Addendum No.: 3

Date Of Addendum: 4/15/2026

**Underground Storage Tank Replacement at Harwinton Consolidated School
115 Litchfield Road, Harwinton, CT 06791
State Project 210-0037CVOT**

1 AST PIPING AND CONTROLS SCHEMATIC DIAGRAM
SCALE: NTS

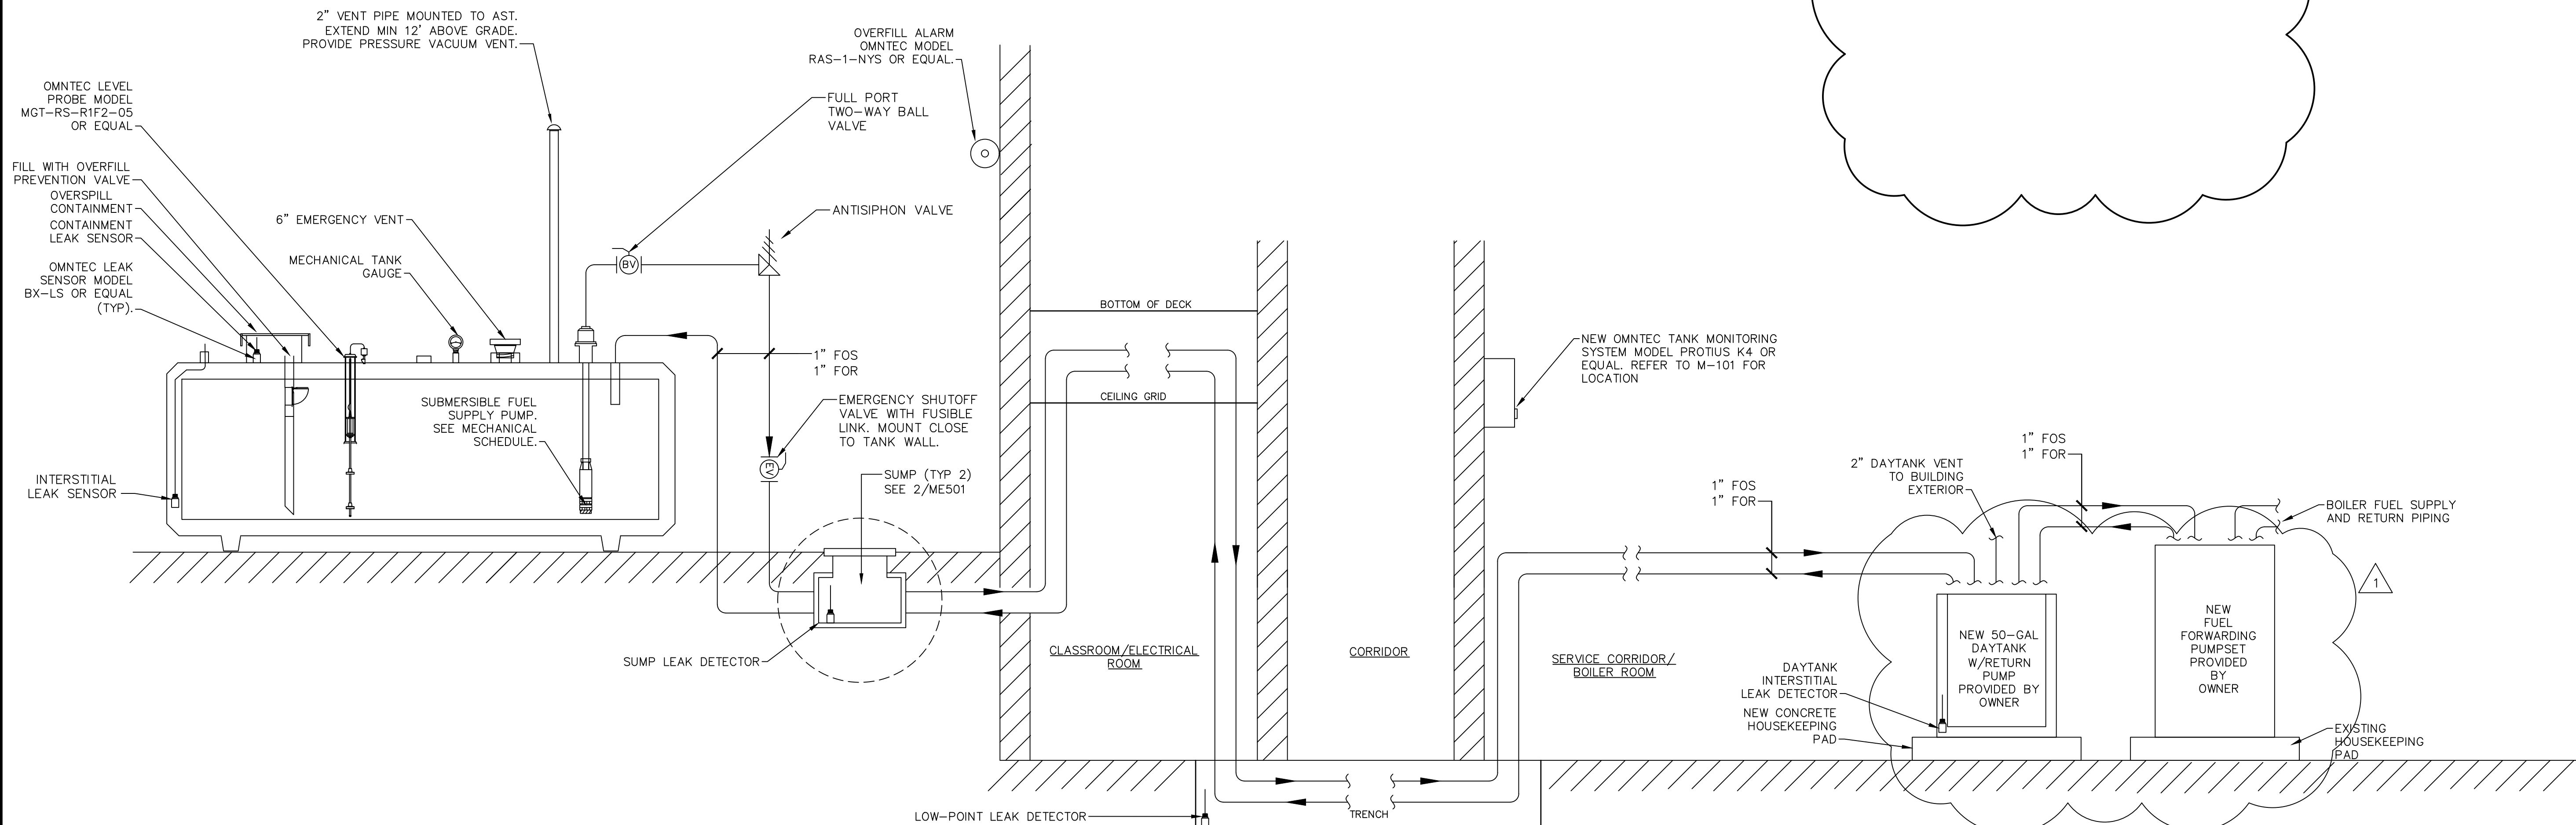
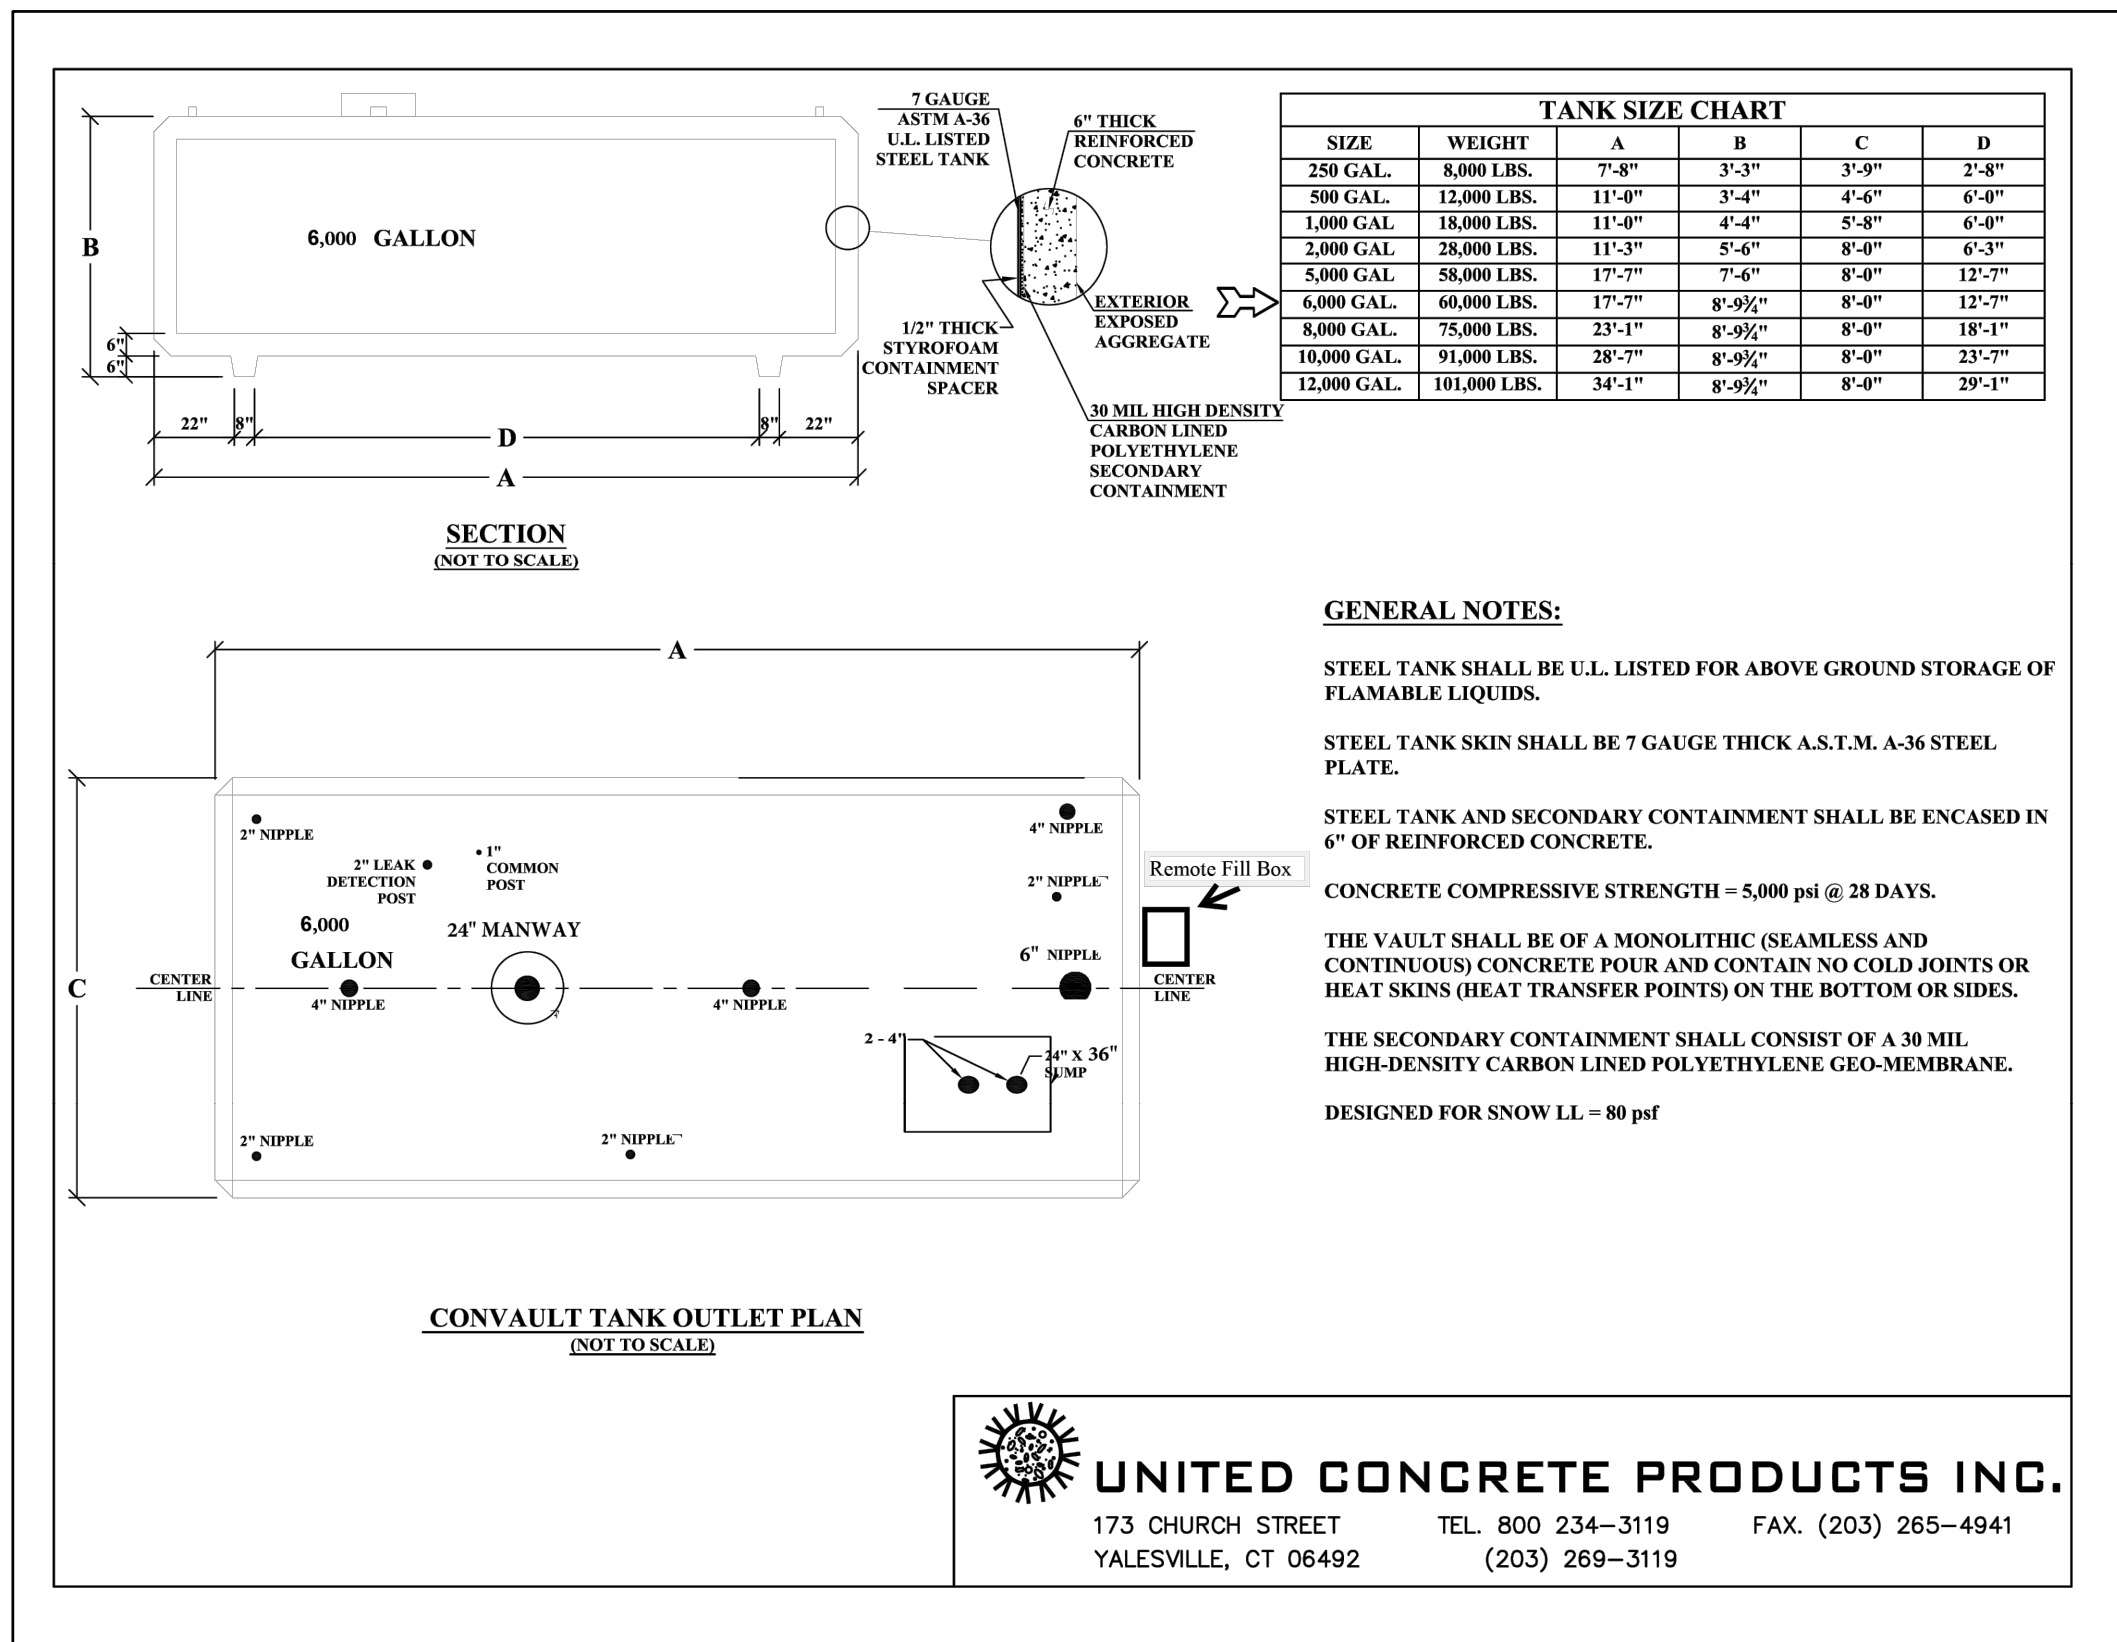
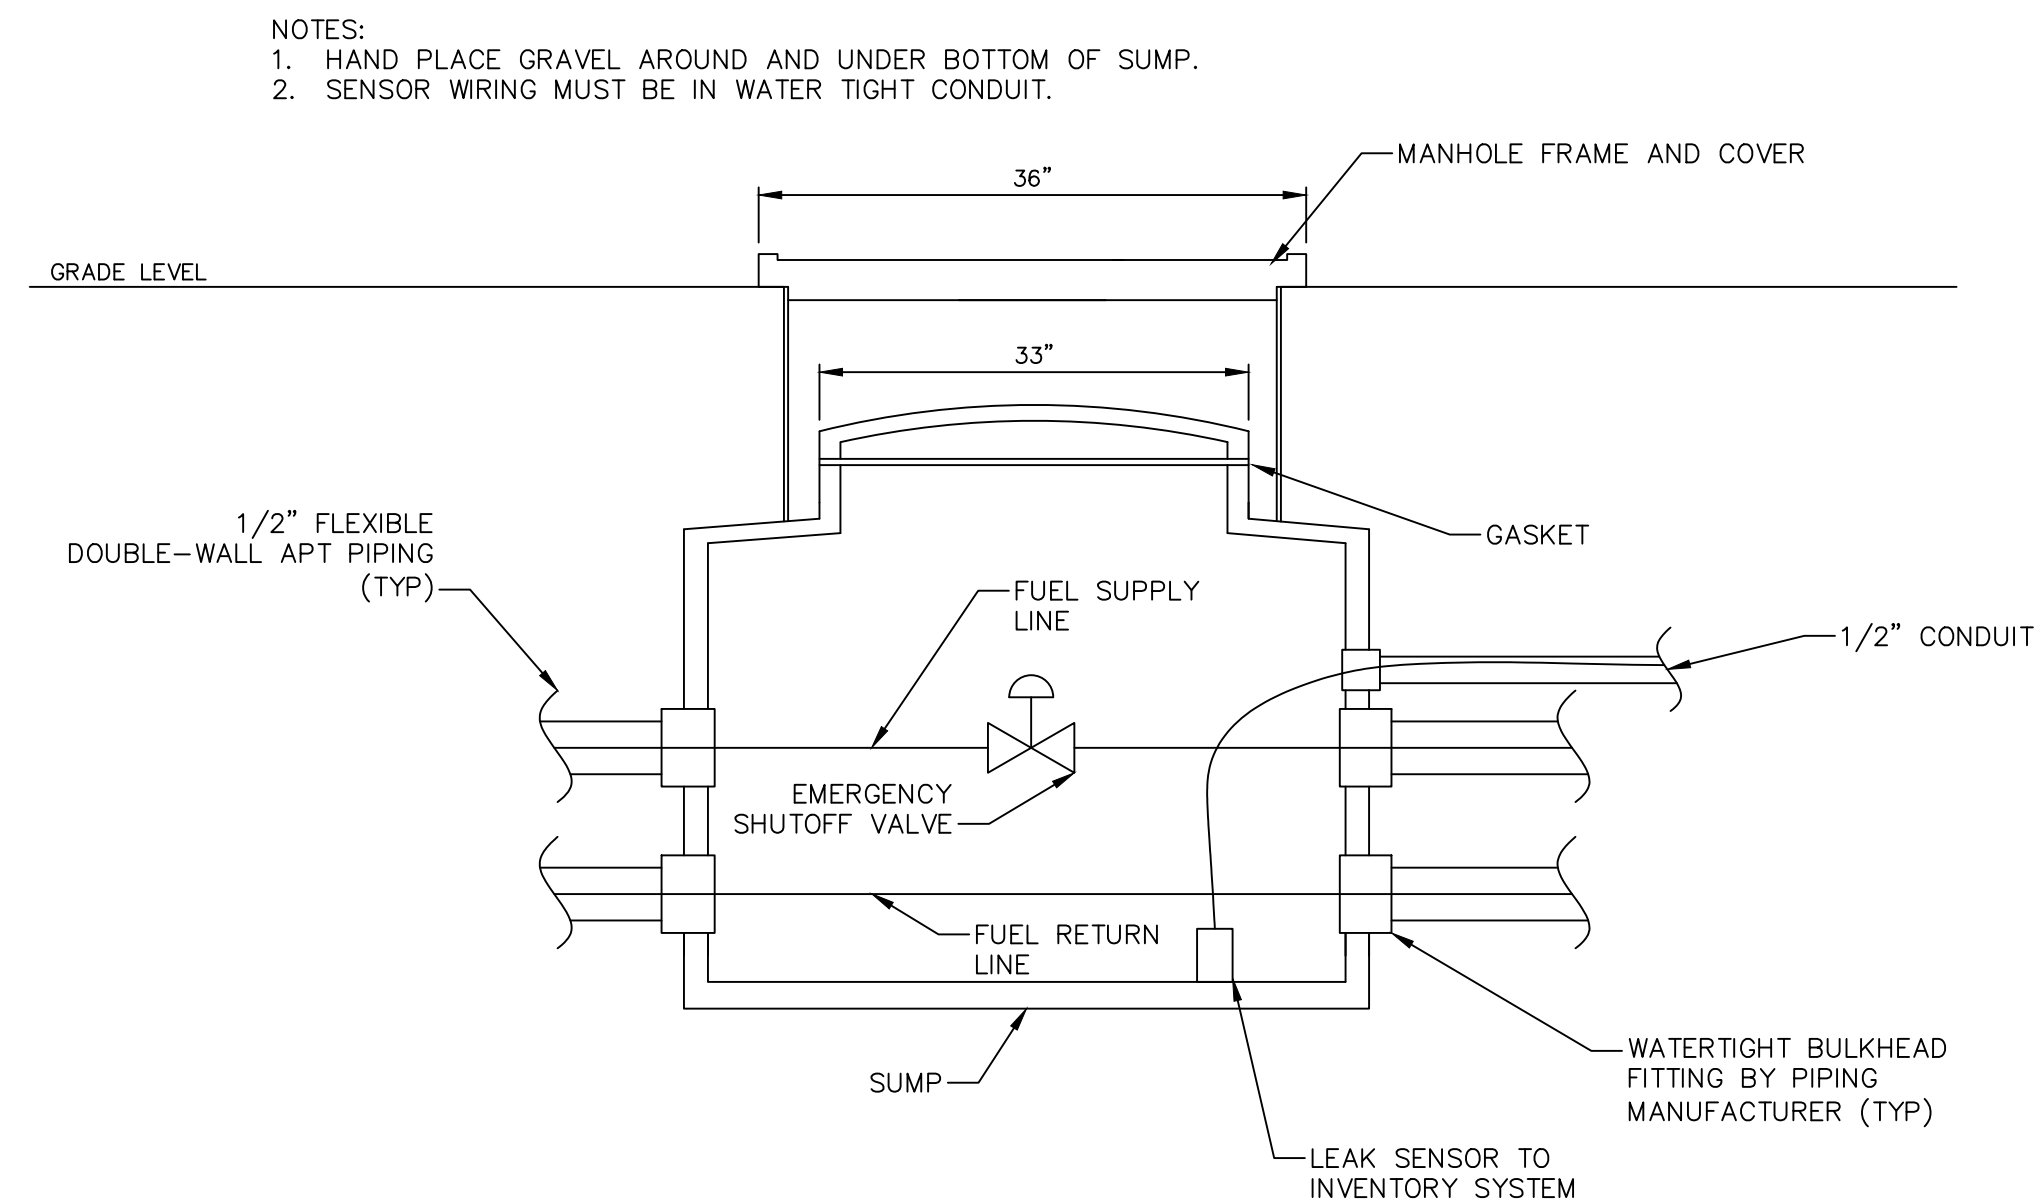
Scope Change: Due to extended lead times, RSD-10 intends to purchase the alternate bid daytank with return pumpset, as well as the replacement duplex boiler pump set from Pryco prior to issuing a contract with the selected contractor. Attached are the quotes from Pryco indicating parts included with this equipment (these attachments are the same as Addendum 2). Installation, startup will be by the Contractor. Contractor to provide 4" housekeeping pad for new daytank.

See updated drawings M-101, M-501 and M-502.
